**ADDENDUM NO. 4 TO PROJECT NO. 47175**

**CONSTRUCTION, ELEVATOR, HVAC, PLUMBING AND ELECTRICAL WORK  
REPLACE ELEVATORS 1 – 5  
DULLES STATE OFFICE BUILDING  
317 WASHINGTON ST  
WATERTOWN, NY**

August 10, 2023

3 Enlarged Eleventh Floor Plan  
1/4" = 1'-0"

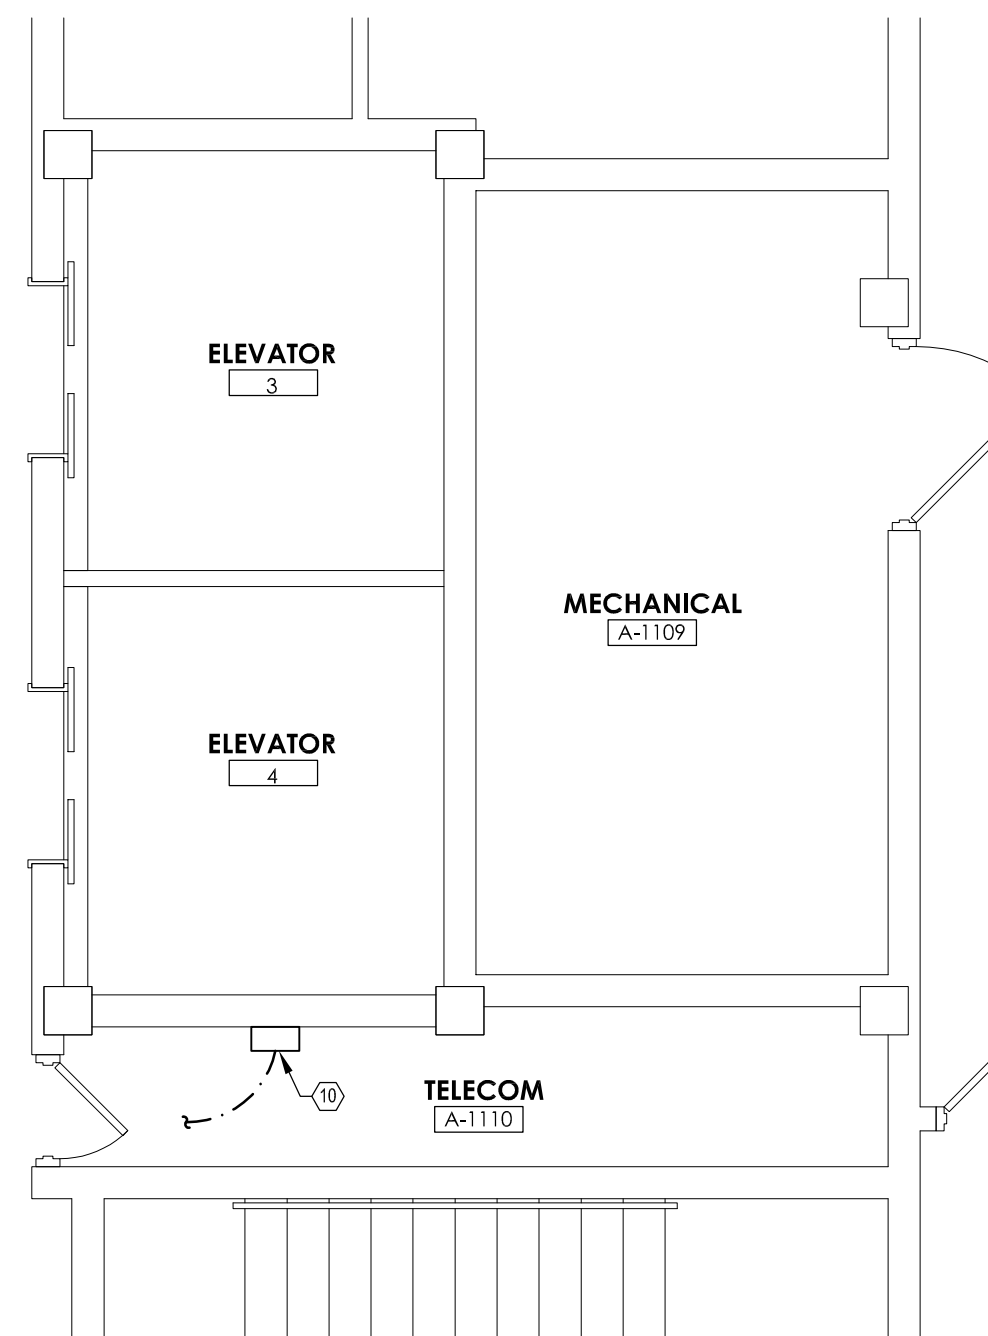
8. Revised Drawings:
  - a. Drawing No. M-001 and M-402, noted “REVISED DRAWING 8/10/2023” accompany this Addendum and supersedes the same numbered originally issued drawing.

- 3/8" LIQUID AND 3/4" GAS REFRIGERANT PIPING TO ACCU-1. MOUNT AC-1 ABOVE EXISTING MOTOR OPERATED DAMPER.
- MOUNT CONDENSING UNIT ON WALL WITH FACTORY OPTION WALL MOUNTING BRACKET. EXTERIOR WALLS ARE ACM. ACCU-1 MOUNTING BRACKET TO BE INSTALLED BY ABATEMENT CONTRACT.

- DRAIN CONDENSATE FROM AC-1 INDIRECTLY TO EXISTING FLOOR DRAIN. REFER TO 2/M-001 FOR INDIRECT DRAIN DETAIL.
- 1/4" LIQUID AND 3/8" GAS REFRIGERANT PIPING UP TO FIRST FLOOR. PROVIDE FIRESTOPPING AT FLOOR PENETRATIONS TO MAINTAIN EXISTING FIRE RATINGS. REFER TO 2/M-402 FOR CONTINUATION.

- CONNECT 1/2" COPPER COND PIPING INTO EXISTING 6" ST PIPING WITH CHECK VALVE.
- INTEGRATE AC-1/ACCU-1 INTO EXISTING SIEMENS BUILDING AUTOMATION SYSTEM (BAS) PANEL LOCATED IN TELECOM A-1110. REFER TO 3/M-402. PROVIDE VISUAL GRAPHIC AND MONITOR THE FOLLOWING POINTS: ON/OFF STATUS, ROOM TEMPERATURE, AND ROOM TEMPERATURE SETPOINT. PROVIDE CONTROL OF THE FOLLOWING POINTS THROUGH THE BUILDING AUTOMATION SYSTEM: ON/OFF, AND SETPOINT. GENERATE BAS ALARM IF ROOM TEMPERATURE DEVIATES FROM SETPOINT BY MORE THAN 5° F. PROVIDE CONTROL WIRING CONNECTIONS TO AC-2/ACCU-2. REFER TO E-CONTRACT DRAWINGS FOR BAS WIRING.

- EXISTING SIEMENS BUILDING AUTOMATION SYSTEM (BAS) PANEL. INTEGRATE SIGNAL FROM AC-1/ACCU-1.
- INTEGRATE AC-2/ACCU-2 INTO EXISTING SIEMENS BUILDING AUTOMATION SYSTEM (BAS). PROVIDE VISUAL GRAPHIC AND MONITOR THE FOLLOWING POINTS: ON/OFF STATUS, ROOM TEMPERATURE, AND ROOM TEMPERATURE SETPOINT. PROVIDE CONTROL OF THE FOLLOWING POINTS THROUGH THE BUILDING AUTOMATION SYSTEM: ON/OFF, AND SETPOINT. GENERATE BAS ALARM IF ROOM TEMPERATURE DEVIATES FROM SETPOINT BY MORE THAN 5° F. PROVIDE CONTROL WIRING CONNECTIONS TO AC-2/ACCU-2. REFER TO E-CONTRACT DRAWINGS FOR BAS WIRING.

- MOUNT AC-1 ABOVE EXISTING LOUVER, APPROXIMATELY 6'-8" AFF.
- INTEGRATE SUMP PUMP INTO EXISTING SIEMENS BUILDING AUTOMATION SYSTEM (BAS). PROVIDE VISUAL GRAPHIC AND MONITOR THE FOLLOWING POINTS: ON/OFF STATUS. GENERATE BAS ALARM IF SUMP PUMP IS ON. PROVIDE CONTROL WIRING CONNECTIONS TO SUMP PUMPS. REFER TO E-CONTRACT FOR BAS WIRING. REFER TO P-CONTRACT FOR SUMP PUMP SCHEDULE AND DETAILS.
